DISCUSSION of:

Ground Improvement Using Preloading with Prefabricated Vertical Drains

Bengt H. Fellenius, Dr. Tech., P.Eng., Canada; email: bengt@fellenius.net

Figure 1. Settlement measured at the benchmarks shifted 10 days.

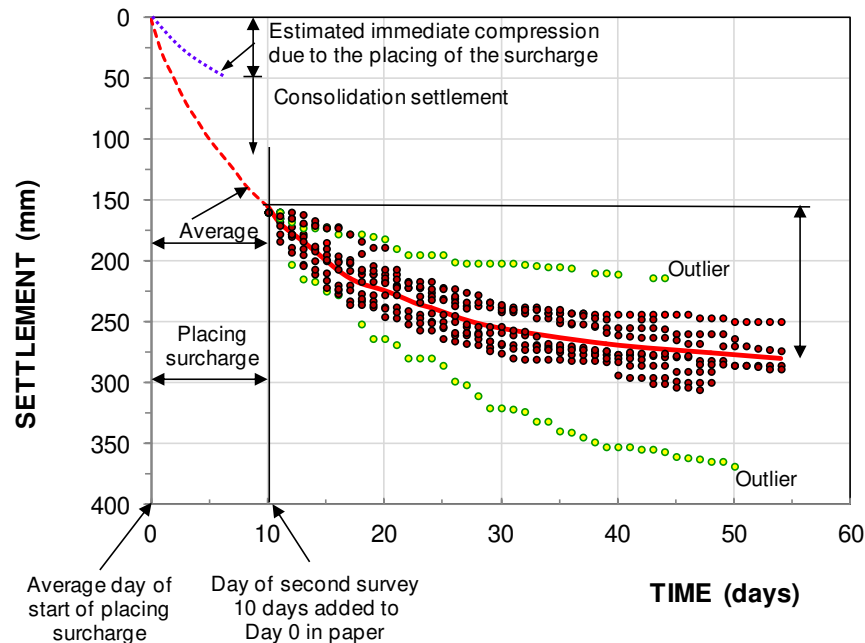
The authors report, that the first survey of the benchmarks was taken before the 3.0-m surcharge was placed across the test area. The first day of settlement measurements for the twelve benchmarks was the date of the second benchmark survey, which was carried out only when all of the surcharge had been placed to the full height over the test area. The time between the first and second surveys—and the placing of the surcharge—ranged from a few days to twenty days. Because the times between the placing of the surcharge and the second survey differed for the benchmarks, the amount of settlement that had occurred at the time of the second survey also differed between the benchmarks. This explains some of the significant scatter displayed in the authors' Figure 13. I have re-plotted the measured settlements in Figure 1 to a common starting point at the average start settlement of 160mm and added 10 days to the authors' measurement days to indicate the average duration of placing the surcharge, which took place before the second survey. During this time, immediate compression and some consolidation will have occurred. As indicated, I estimate the immediate compression to be about 50 mm. I have also added an average curve and extrapolated it back to the origin (the average excludes the two outlier records). All benchmarks appear to show that most of the consolidation had developed at the time the last survey was made.

Figure 2. Settlement measured at the benchmarks normalized to the average end values.

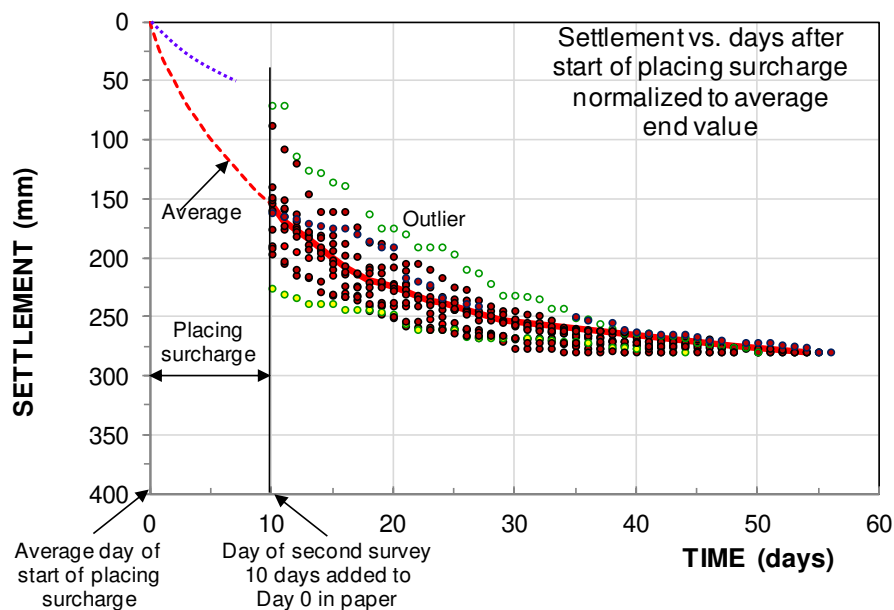
Figure 2 shows the measured final settlements are normalized to the average final settlement (280 mm). There is still much scatter between the curves, but now the approximate start date for each curve can be obtained by sliding the curves left or right until the best agreement to the average curve is obtained as shown in Figure 3. The removal of much of the scatter—the agreement between the time-settlement curves—is of course to some extent fictitious as the benchmark measurements cannot be expected to be all that similar; a natural variation must have taken place, not least with regard to the thickness of the soft clay layer. However, I believe that the figure suggests a reasonably realistic day for the start of placing the surcharge.

Figure 3. Settlement measured at the benchmarks adjusted to obtain the approximate start day.

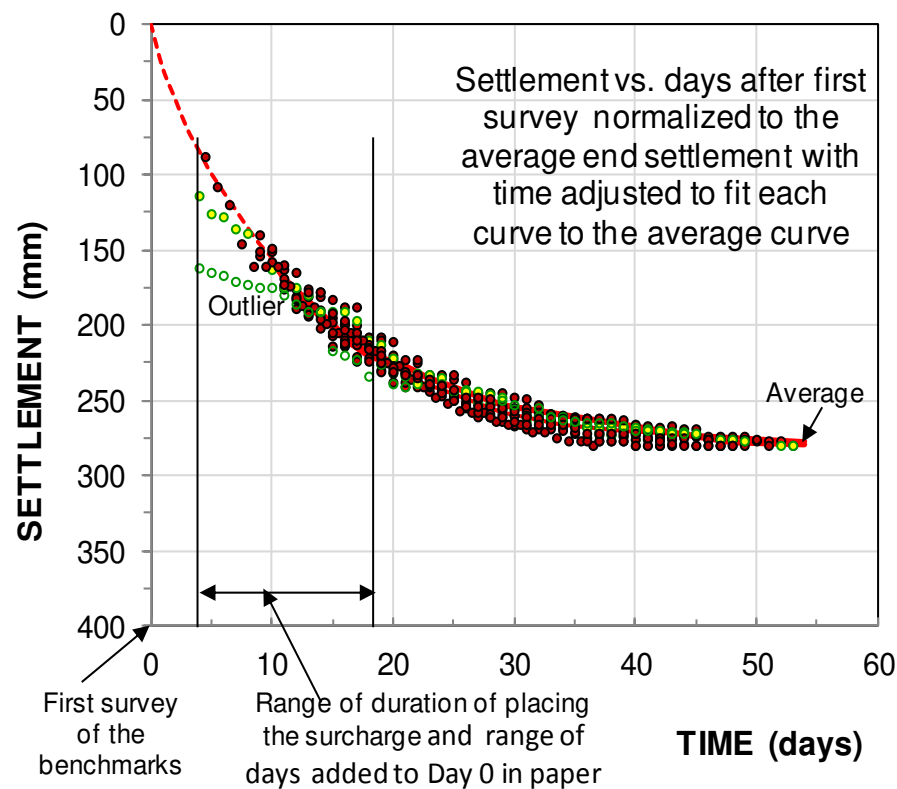
The average curve shown in Figure 3 can now serve as reference to a back-calculation of the time-settlement development for the wick-drain project to determine compressibility and coefficient of consolidation of the soil layers. The back-calculation consists of applying the theory of pore pressure dissipation in fine-grained soils (consolidation) due to radial flow (Barron 1948, Kjellman 1948, and Hansbo 1960; 1979) is based on radial flow toward a circular drain in the center of a cylinder of homogeneous soil with an impervious outer boundary surface). The theory is summarized in the Kjellman-Barron formula, Equation 1. The Kjellman-Barron formula is based on the assumption of horizontal (radial) flow only and a homogeneous soil.

Figure 4. Average measured and calculated settlements.

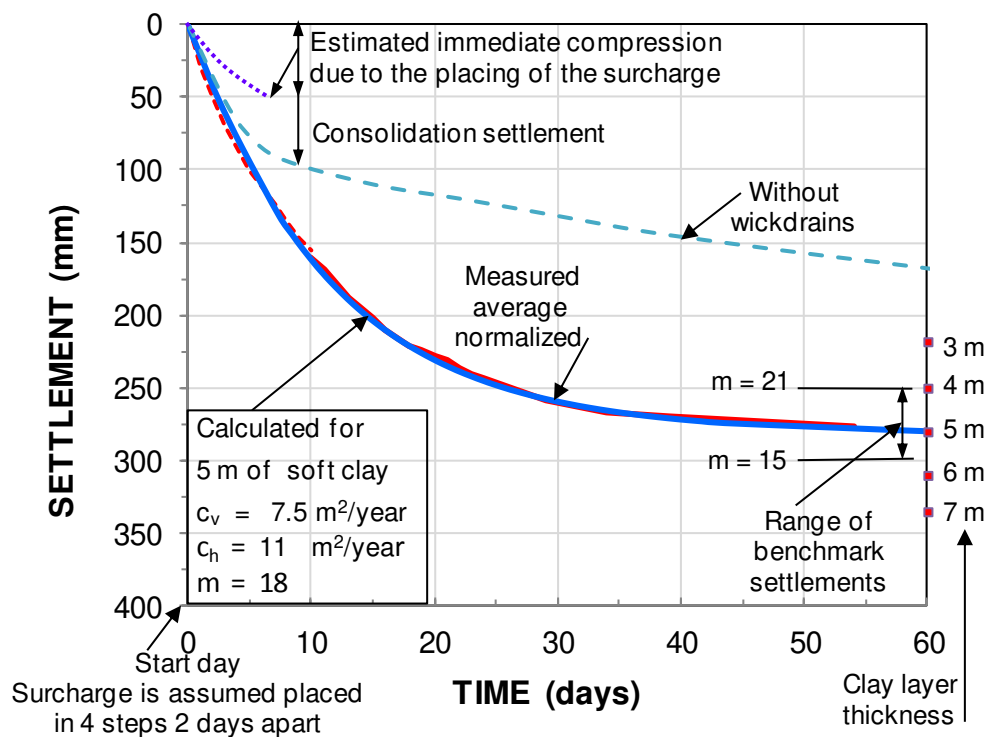
The results of the back calculation are shown in Figure 4 together with the average curve of the measurements. In order to show the sensitivity of the clay layer thickness and modulus number, the figure also shows the final settlement for soil layer thickness ranging from 3 through 7m and the final settlement resulting from modulus numbers of 15 and 21. The figure also shows the settlement during the first 60 days that would have occurred had there been no wick drains (for this input, I used the authors' 7.5m²/year c_v -coefficient).

Considering that my data reduction is quite different to that of the authors, my back-calculated c_h -coefficient (11m²/year) agrees well with the authors' laboratory-established value (14m²/year). The difference could be taken to represent the effect of a smear zone. However, considering all the uncertainties involved, I believe the agreement to be entirely fortuitous.
